Subject: Final Construction Inspection, Albion-Sheridan Township Landfill

**FINAL INSPECTION
ALBION-SHERIDAN TOWNSHIP LANDFILL
NOVEMBER 2, 1999
ALBION, MICHIGAN**

From:
Drawing 10 of
10

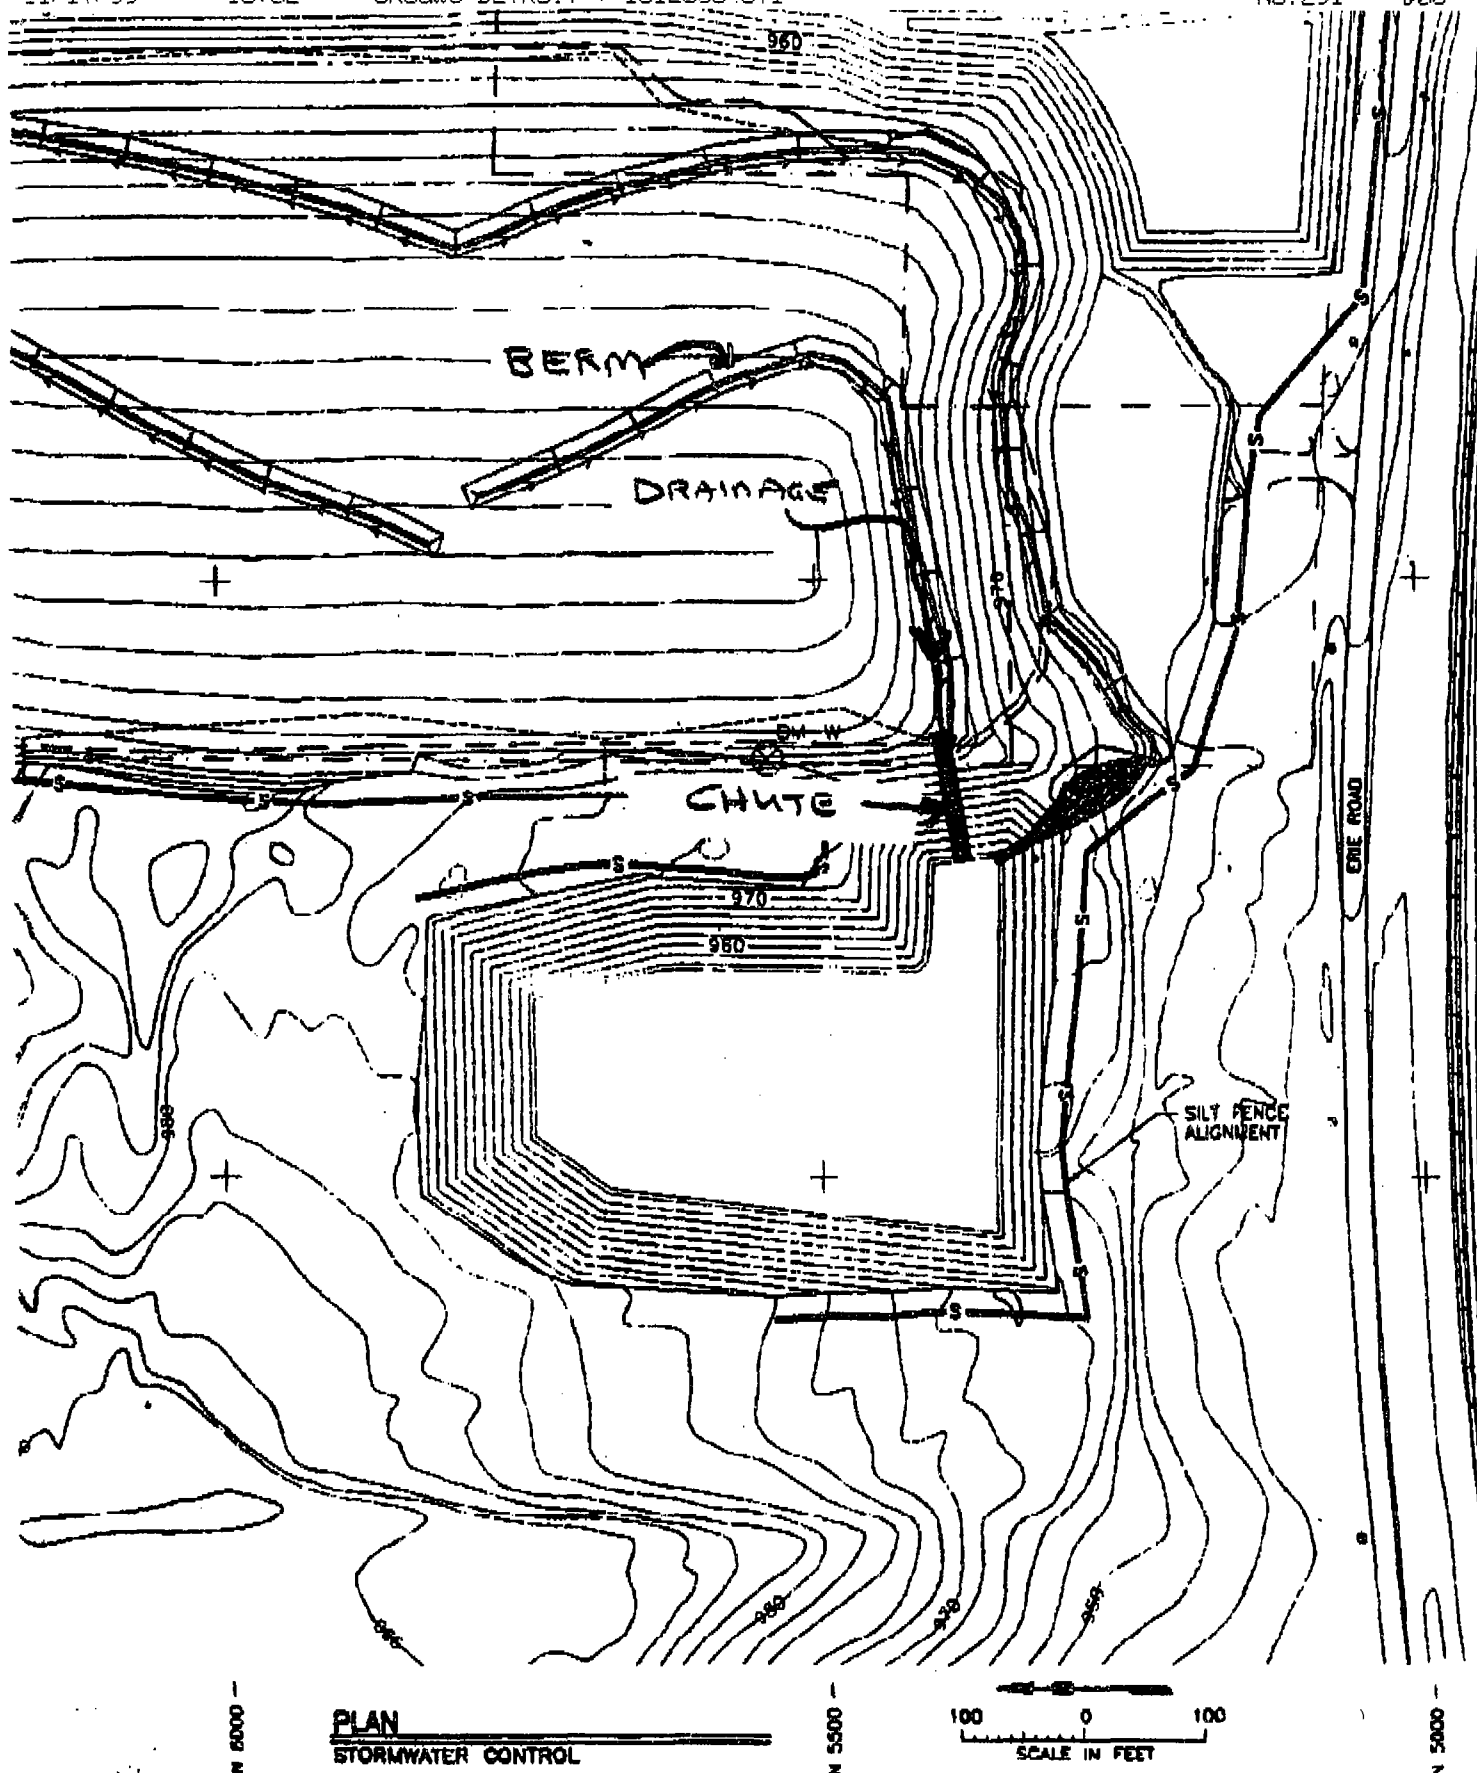
11. The rip rap chute in the southwest corner of the landfill appeared to not convey the water from the slopes. In accordance with the design, the chute is designed to convey the surface water only from the southern berm located on top of the landfill (see attached sketch). Based upon the observations of the Resident Engineer during a rainfall event, the chute received water from the southern berm and performed as designed. The surrounding land surface areas are designed to drain surface water runoff as sheet flow into the west drainage retention basin.
